ADDENDUM NUMBER 3

R18-01 Island Savings Centre Lobby Washroom Upgrades

January 25, 2018

Electrical Addendum E-03

REMOVE ALL ELECTRICAL DEVICES INCLUDING LIGHTING, RECEPTACLES, EMERGENCY LIGHTS ETC. UNLESS OTHERWISE NOTED. REFER TO RENOVATION PLANS FOR NEW POWER AND LIGHTING SCOPE
- 2

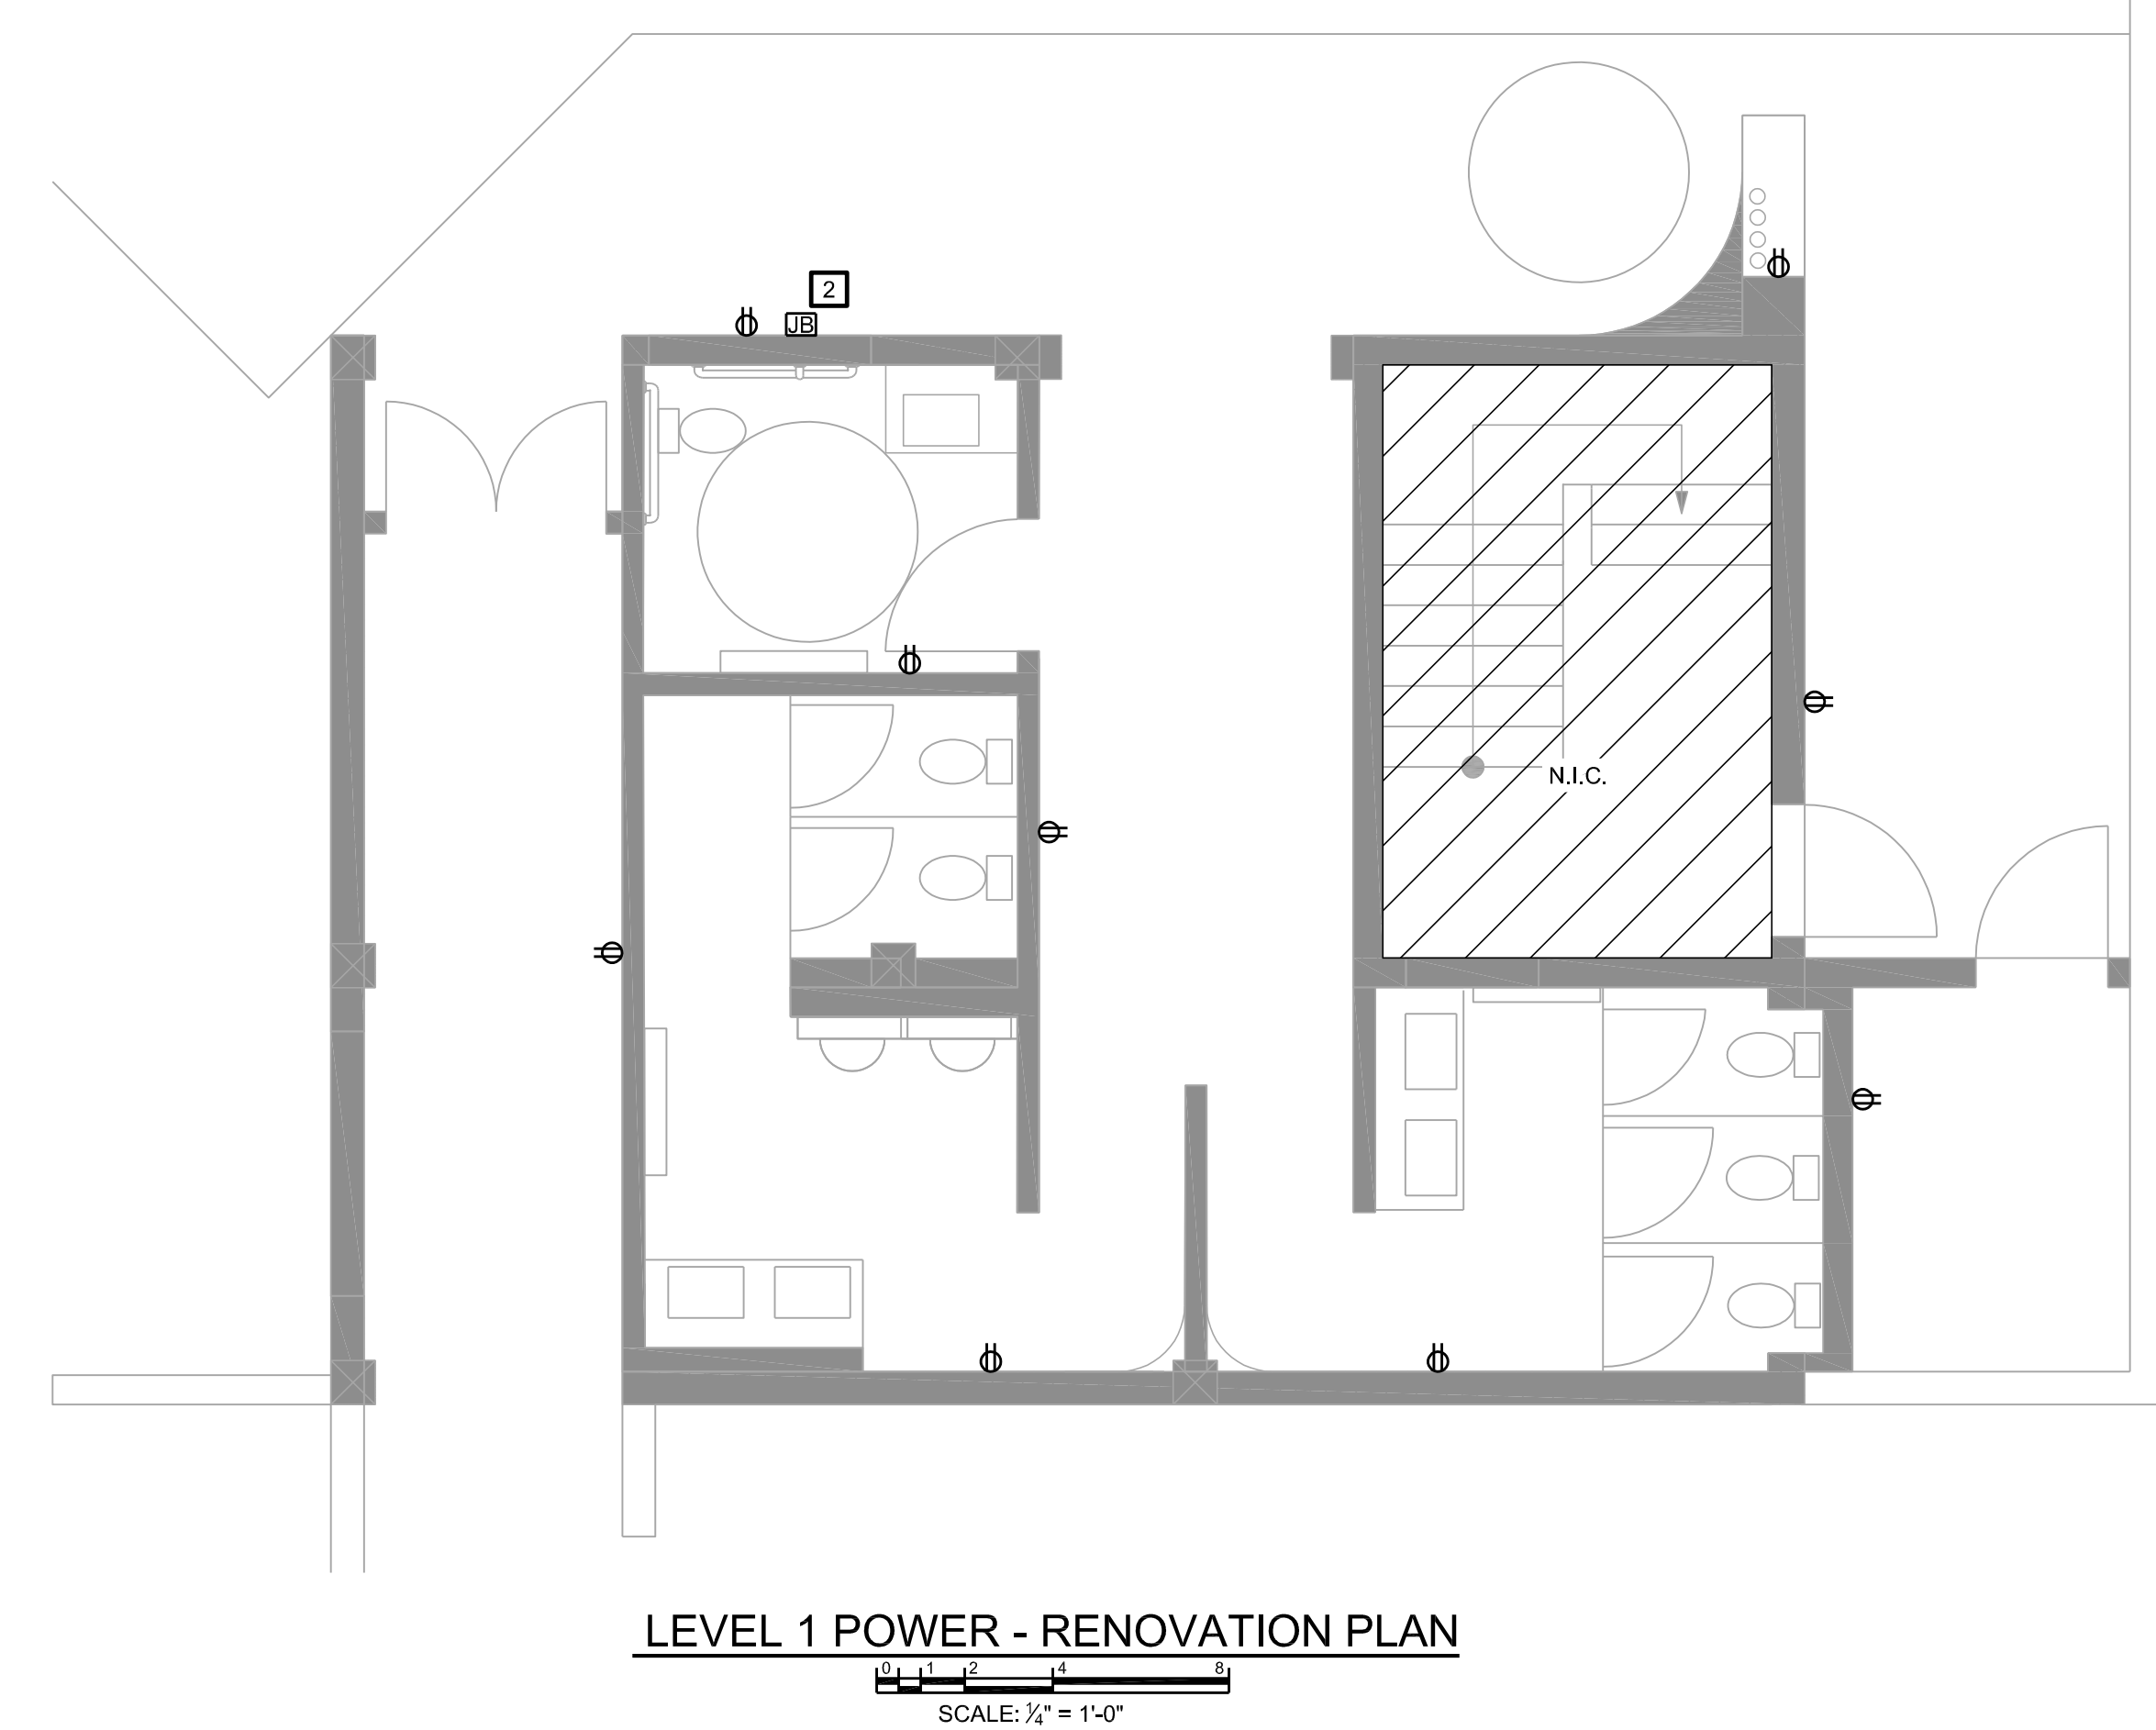
Q2. The electrical drawings don't seem to reflect any emergency lighting other than exits, are they required in the washrooms? Please provide all locations for emergency lighting.

Q3. While Addendum 2 does provide information/locations for the emergency exit lights, the location of "emergency battery pack lights" and their locations are not shown on the drawing. The assumption would be that emergency lighting would be required in each of the washrooms, washroom corridor and back corridor. Please provide clarity for these locations.

- 1.1 **REVISE** fire alarm system specification. See attached drawing E-0
- 1.2 **ADD** emergency lights to washrooms and corridors. See attached drawing E-1

A2. [See Electrical Addendum E-3.](#)

A3. [See Electrical Addendum E-3.](#)
